**RE: Technical Comments on Revision 23-1 No Agua Mine Updated Closeout Plan, Revision 23-1, Permit No. TA005RE**

# **Attachment A: MMD Technical Comments**

**No Agua Mine Revision 23-1**

**Permit No. TA005RE**

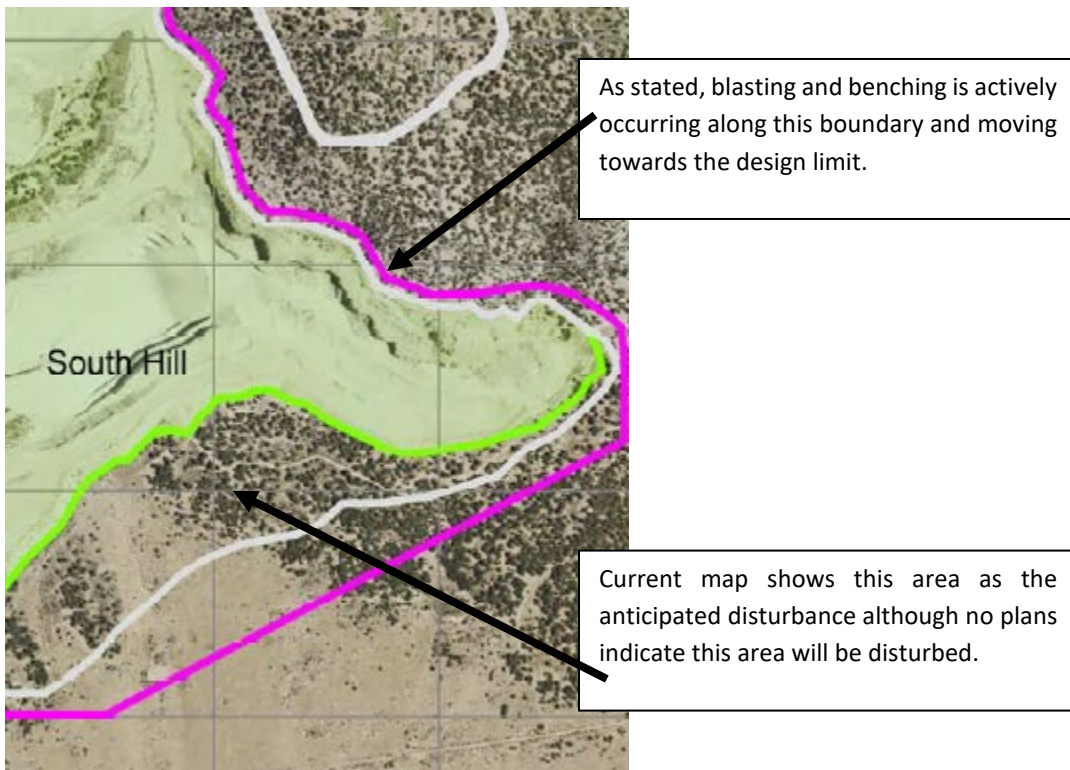
25. Figure 1: MMD is requesting updated maps for on-going and future reference. MMD is requesting the below characteristics be included.

Site-Specific Characteristics:

- a. Confirm 5-year disturbance/design limit for South Pit (see annotated map below),
- b. Fines dump locations (including prospective third dump location, if needed),
- c. Overburden dump,
- d. Cover material storage,
- e. Label the new "508" and existing units "507",
- f. Well location,
- g. New proposed test plot locations,
- h. Historic test plot locations (3) and,
- i. Catch Basins (4)
